Car Stereo Service Bulletin

Model: XR-5250

No. 263

Subject: Procedure For Changing Tuning Intervals
to U.S. Standards

CSA-14 Tuner/Tape Deck

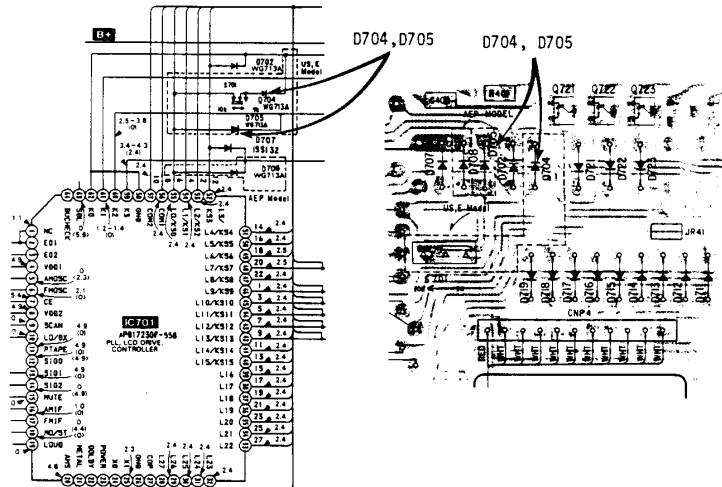
The FM tuning interval on this model is set at 50KHz. The AM tuning interval is switch-selectable between 9KHz and 10KHz steps.

Follow the procedure below to change the tuning intervals to U.S. standards (200KHz steps for FM; 10KHz steps for AM).

1. Remove D-704
2. Remove D-705
